Arlington Zoning Board of Appeals

2. #3747 10 Sunnyside Avenue

Reference Material	2023-06-13_10_Sunnyside_ZBA_Hearing_3_Presentation.pdf	ZBA Hearing 3 Presentation
Reference Material	Henderson_Letter_10_Sunnyside.pdf	Henderson_Letter 10 Sunnyside
Reference Material	2023-06-09_10_Sunnyside_Arlington_Civil_Set_Plan_Updates_-_Revised.pdf	2023-06-09_10 Sunnyside Arlington Civil Set Plan Updates - Revised
Reference Material	2023-06-13_10_Sunnyside_ZBA_Hearing_3_Presentation_-_Revised.pdf	2023-06-13_10 Sunnyside ZBA Hearing 3 Presentation - Revised

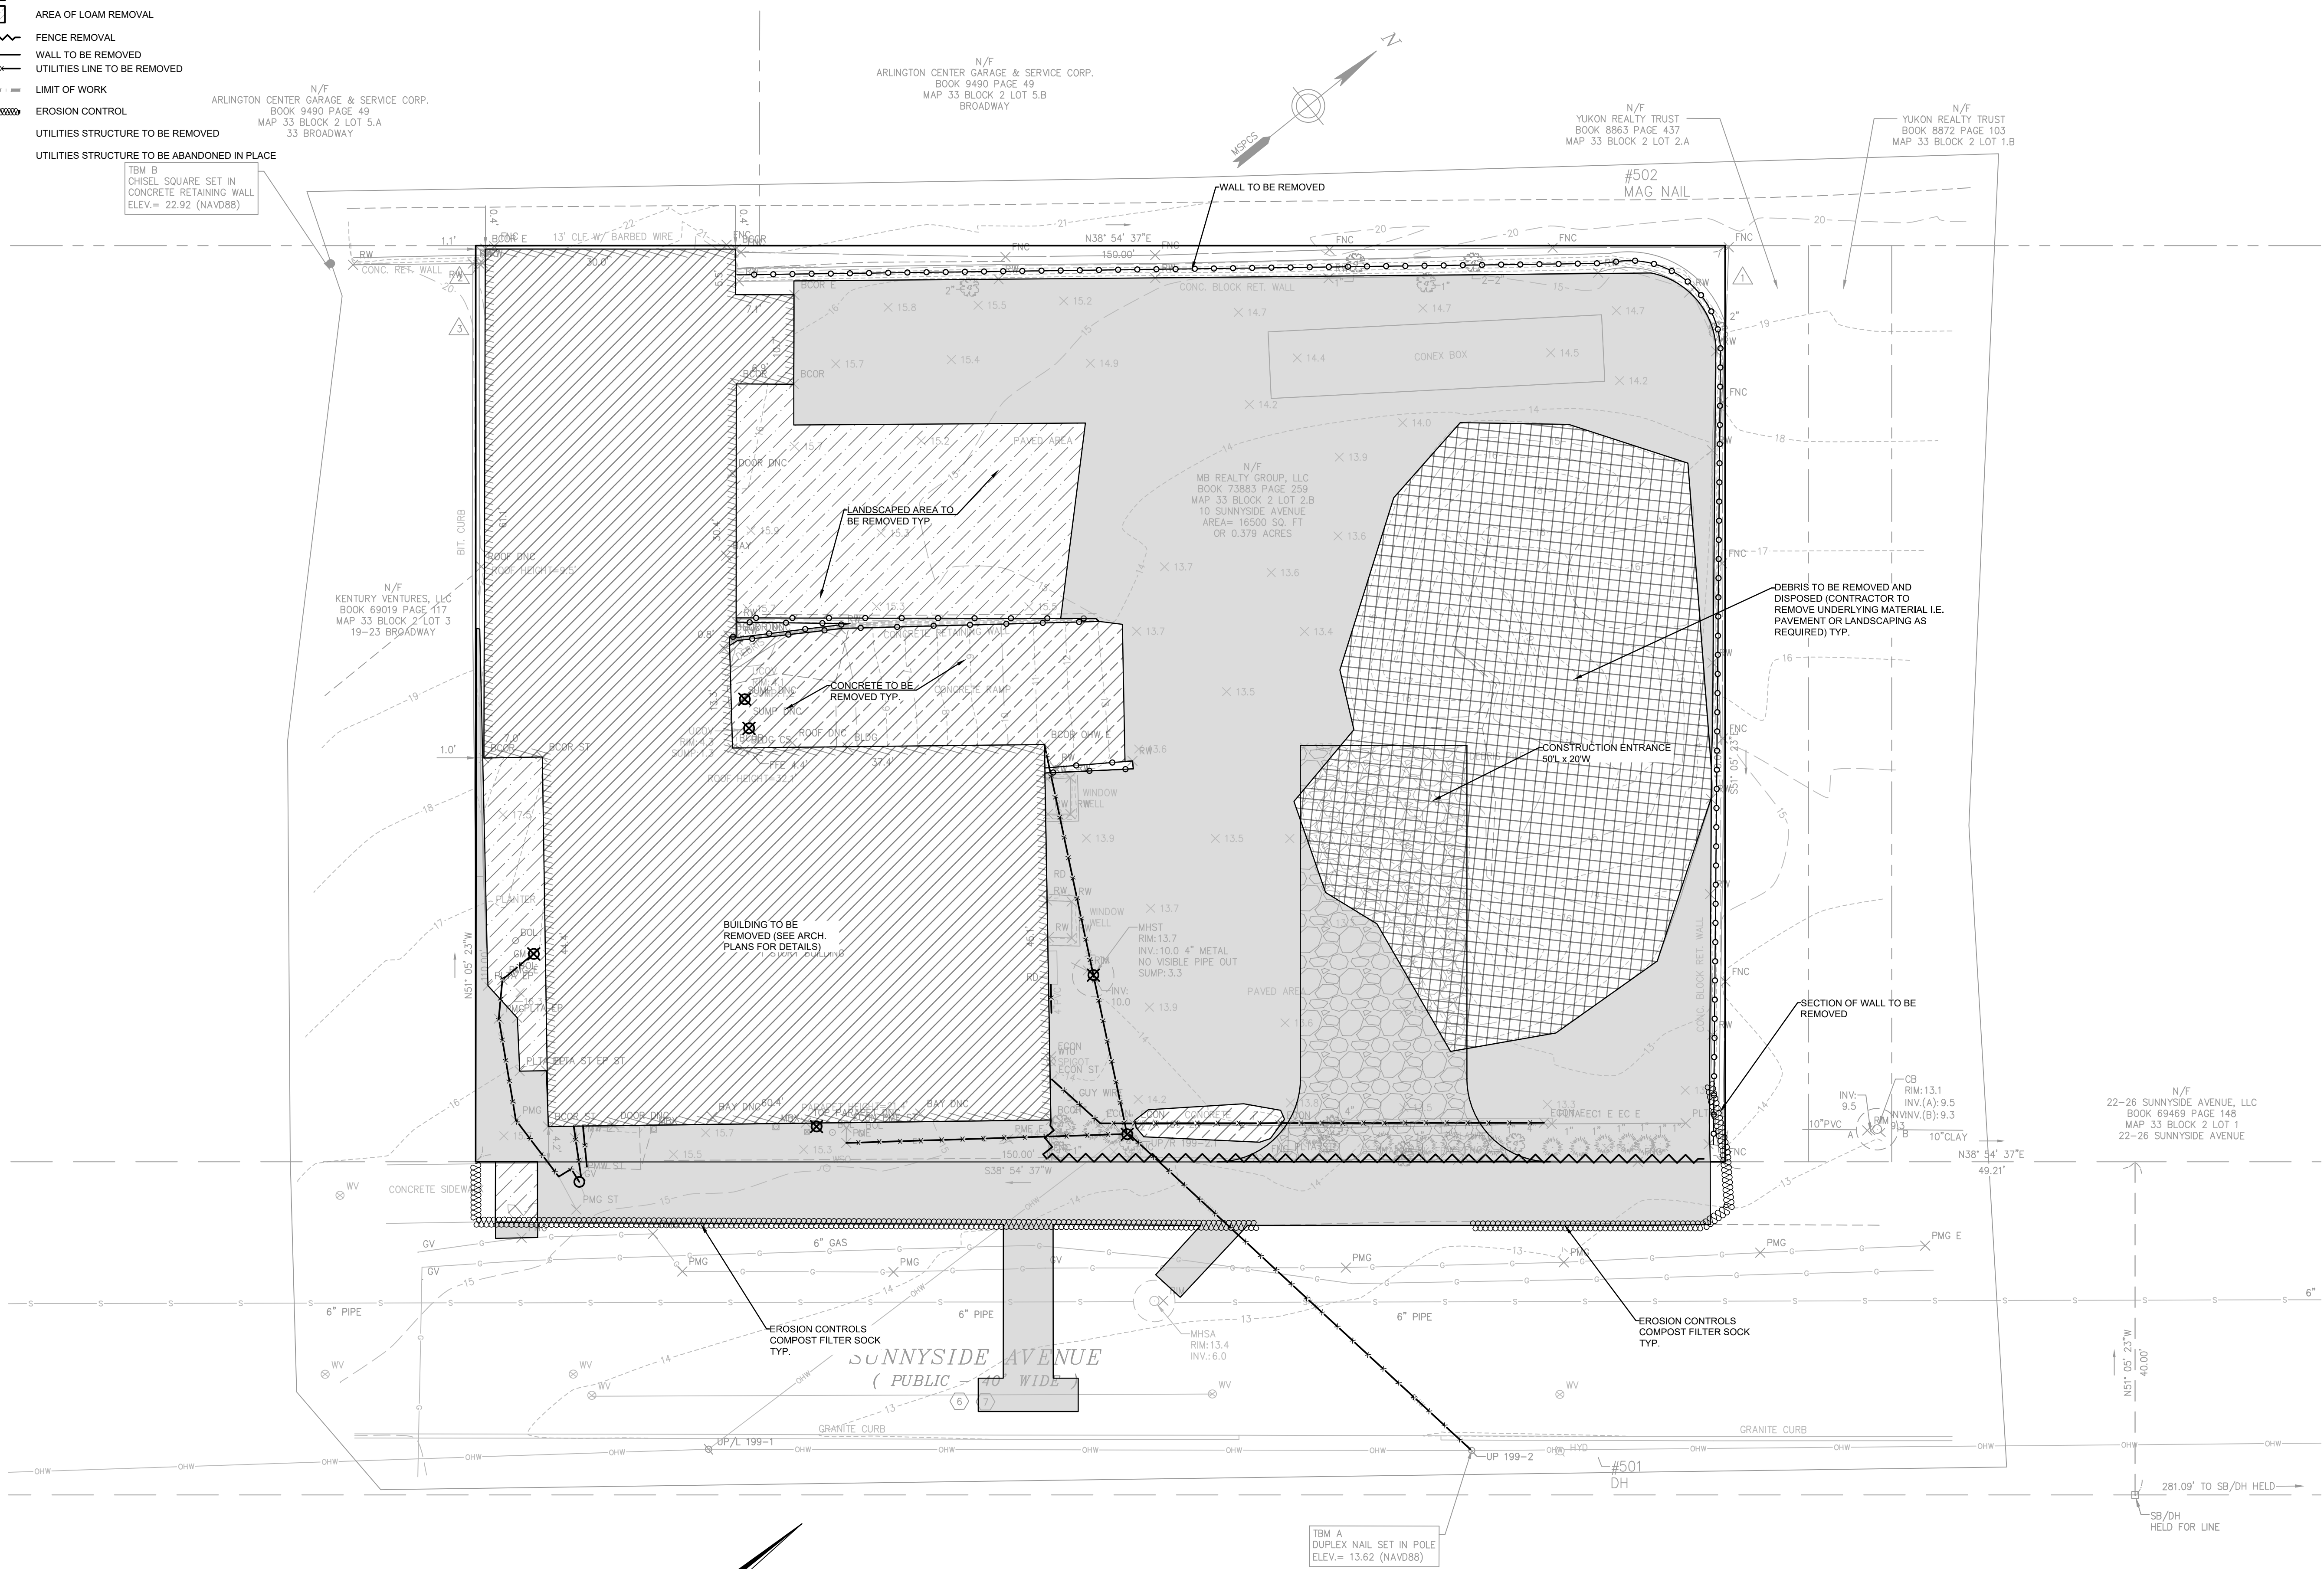
- Will PV panels be flat or raised ?

Response: PV panels will be ballasted roof-mount system approximately 18" tall; they will not be visible from the street.
